Subject: [Departmental Comments (Batch 2)] Planning Application No. A/YL-SK/445 - Temporary Logistics Centre and Workshop for a Period of 3 Years

I refer to the planning application No. A/YL-SK/445 for Temporary Logistics Centre and Workshop for a Period of 3 Years at Lots 580 (Part), 595, and 598 S.B. (Part), D.D. 114, Wong Chuk Yuen, Shek Kong, Yuen Long.

TEMPORARY LOGISTICS CENTRE AND WORKSHOP FOR A PERIOD OF 3 YEARS AT LOTS 580(PART), 595, 598 S.A.(PART) AND 598 S.B.(PART) IN D.D. 114, SHEK KONG, YUEN LONG, N.T.

FS NOTES, LEGEND, ABBREVIATIONS AND DRAWING LIST

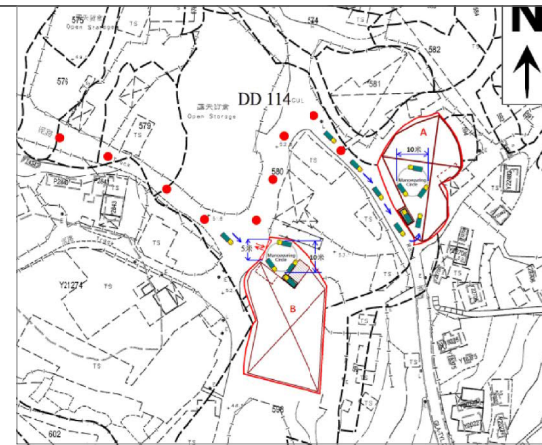
- ix. Schematic drawings are not required to be submitted for vetting;
- x. The structure number specified in items 1.1, 2.1 and 3.1 of the FS Notes for Structure A shall be rectified;

- xi. A complete set of legible FSI proposal shall be provided for Structure A;
- xii. The maximum storage area of a single block (i.e. 50 m²), storage configuration and height regarding the provision of automatic sprinkler system shall be specified in the FS Notes for Structure A;

- 2.1 AUTOMATIC SPRINKLER SYSTEM TO BE PROVIDED TO STRUCTURE A & B CORRESPONDINGLY IN ACCORDANCE WITH LPC RULES INCORPORATING BS EN12845 : 2015 AND FSD CIRCULAR LETTER 5/2020. THE SPRINKLER TANK, SPRINKLER PUMP ROOM, SPRINKLER INLET AND SPRINKLER CONTROL VALVE GROUP SHALL BE CLEARLY MARKED ON PLANS.

- 2.9 STORAGE SHOULD BE CONFINED TO BLOCKS NOT EXCEEDING 50M^2 IN PLAN AREA FOR CATEGORY I.

DRAWING TITLE
PROPOSED FSI LAYOUT PLAN FOR STRUCTURE
A

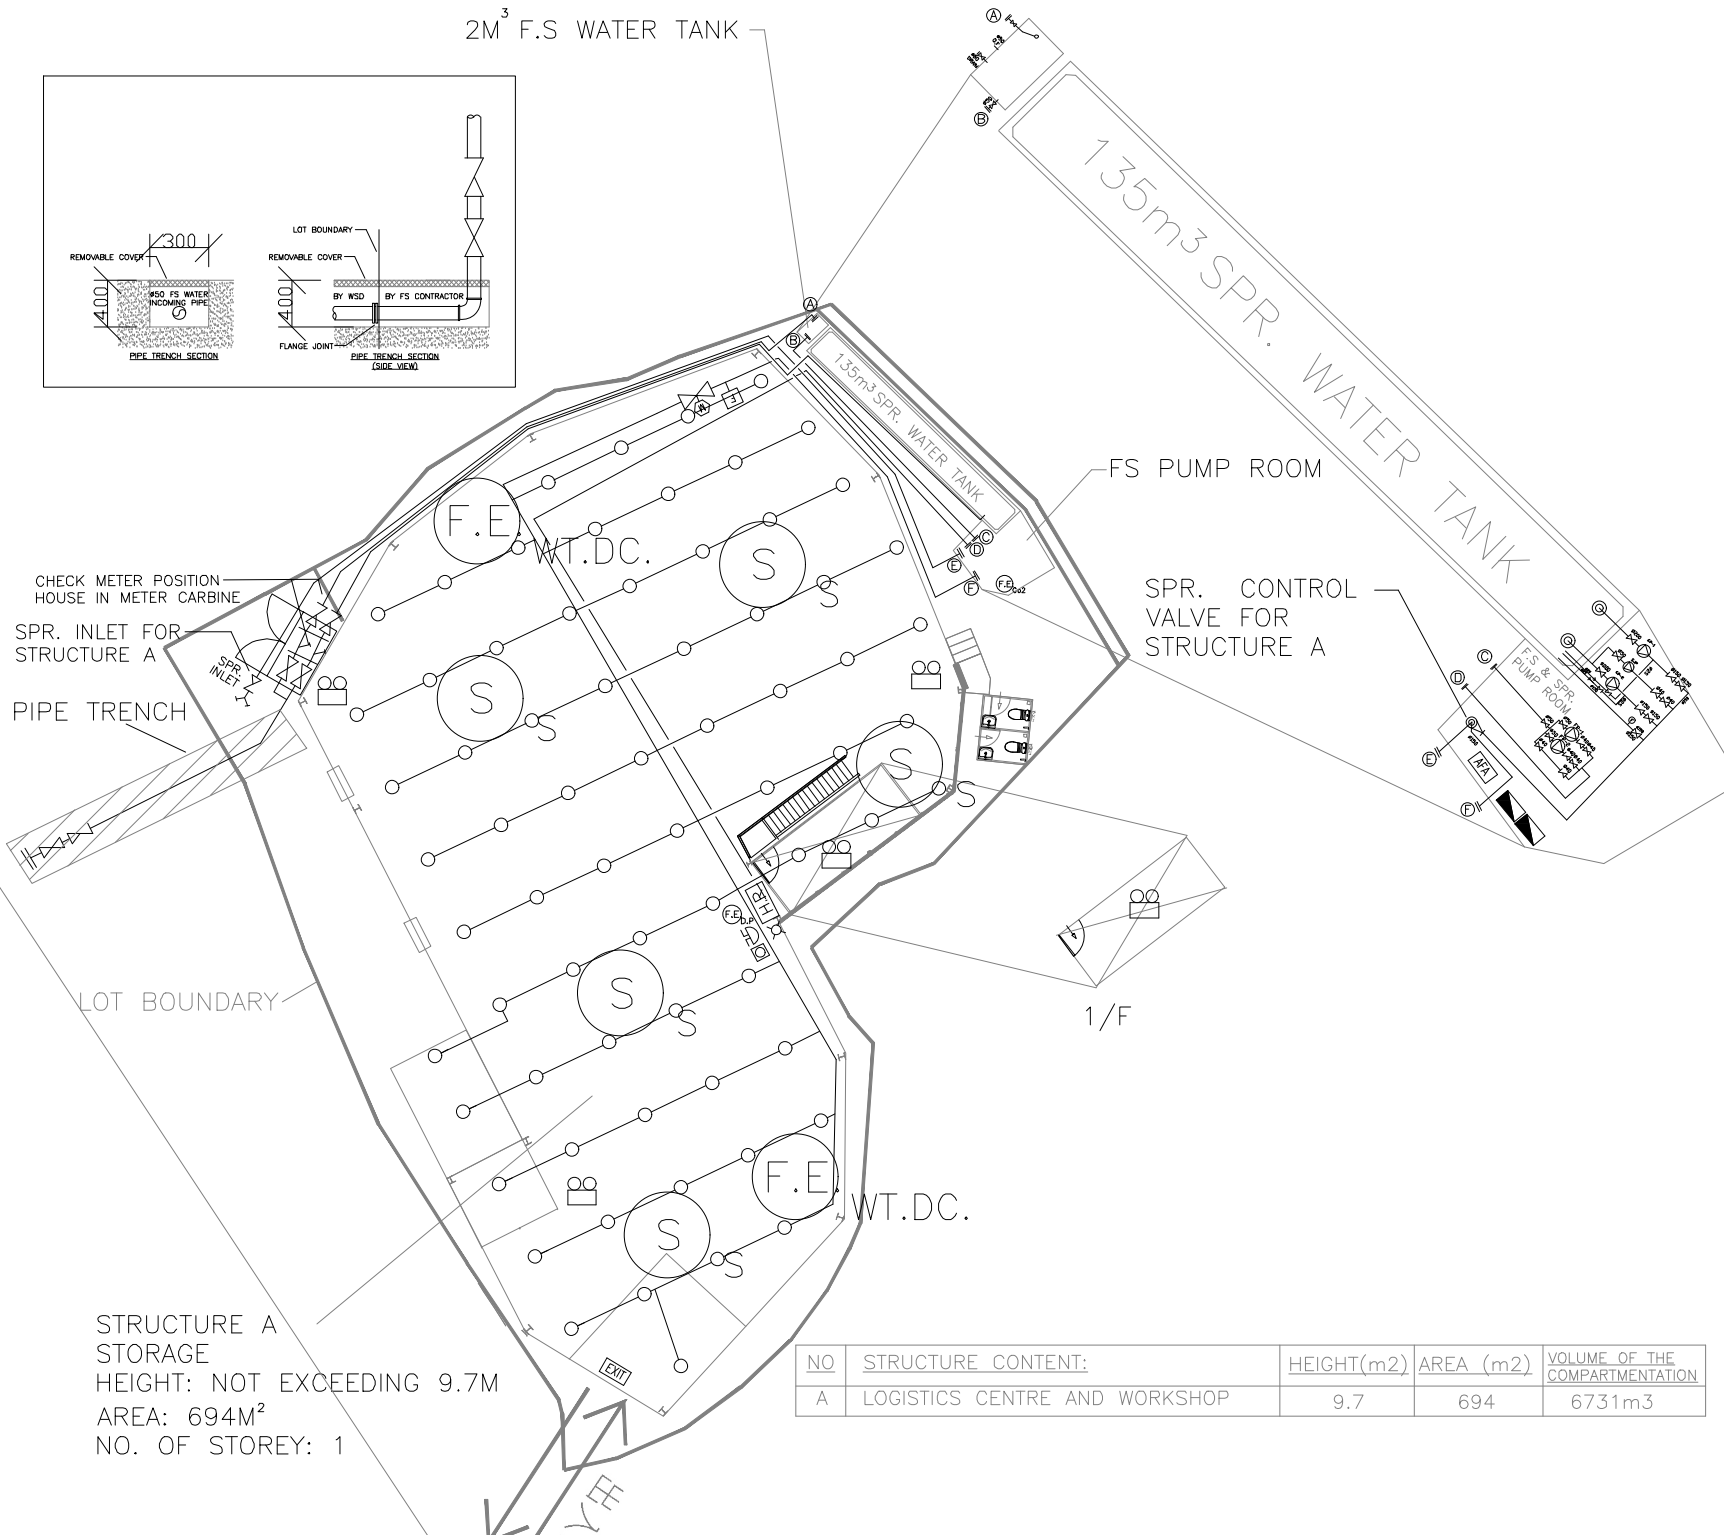
- xiii. The sprinkler inlets shall be positioned in a prominent position on the exterior of Structure A;
- xiv. Emergency lighting, directional and exit signs shall be clearly indicated on the plan for Structure B; and

CHECK METER POSITION
HOUSE IN METER CABINE
SPR. INLET FOR
STRUCTURE A
PIPE TRENCH

SPR. CONTROL
VALVE FOR
STRUCTURE A
